KAWARTHA PINE RIDGE DISTRICT SCHOOL BOARD PUR24-073-ITT

Roseneath Centennial Public School Library Refresh and Corridor Upgrades

ADDENDUM NO. 4

ADDENDUM 01

PARTIAL ROOF PLAN SCALE: 1:100

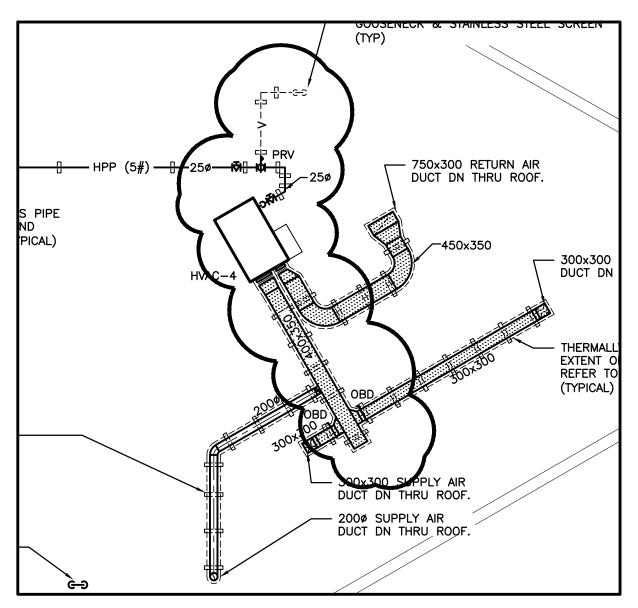
- 1.0 Refer to Drawing M4.1 and Attached Sketch ADD01-M01
 - .1 On drawing M4.1, revise routing of HPP gas piping as per attached sketch ADD01-M01.

- 2.0 Refer to Drawing M4.1 and Attached Sketch ADD01-M02
 - .1 On drawing M4.1, revise placement of HVAC and associated piping and ductwork as per attached sketch ADD01-M02.
